27 September 2019

MAC190946LR1

Noise Assessment Review: PGH Brickworks, Bringelly, NSW.

Extract 3

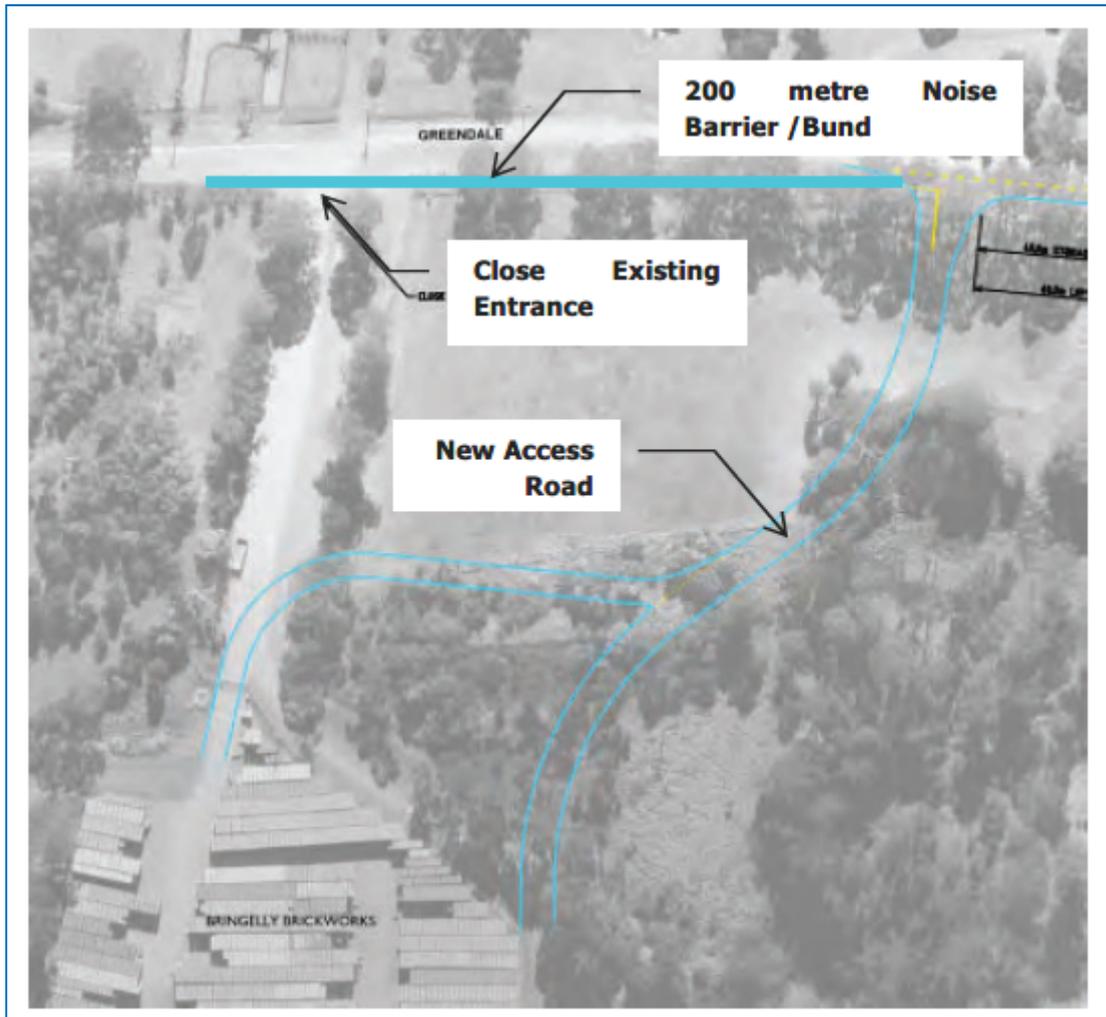
The historic report also concludes that truck noise on the access road is a significant contributor to off-site noise at receivers on Greendale Road by up to 10dBA (refer to **Extract 2**). Therefore, the NA has concluded that the noise contribution from trucks is 54dB LAeq(15min), proposing a noise barrier/bund and relocating the main access road to mitigate noise to satisfy the noise criteria of 44dBA (refer to **Extract 3**).

On-site attended measurements, completed on 11 September 2019, were analysed to calculate the Sound Power Level (Lw) of trucks, entering and exiting the project site. The resulting truck Lw was 95dB LAeq(15min). It is noted that the historic report adopted a Lw of 105dBA (Table 6-1 of the historic report) for noise modelling, at a speed of 10km/h. A truck Lw of 105dBA is considered to be more representative of trucks travelling at higher speeds between 50 to 60km/h. Hence, the historic report has adopted a worst-case methodology for this source which would result in overly conservative noise predictions.

Calculations demonstrate that daytime truck noise whilst on the project site are lower than the criterion of 44dB LAeq(15min). MAC worst case scenario noise calculations are generally consistent with in-field noise measurements. Therefore, based on in-field measurements and revised validation modelling, the noise barrier and access road re-location are not considered necessary to mitigate noise levels from trucks entering and exiting the project site and hence, their construction is not required. Additionally, any residual noise emissions from the brick plant have been attenuated via implementation of noise treatments to the crusher and box feeder buildings.

The review identified that the historic assessment was based on a worst-case assessment approach. Subsequent in-field measurements and revised validation modelling identified the noise barrier and access road re-location are not considered necessary to mitigate noise levels. Therefore, their construction is not required.
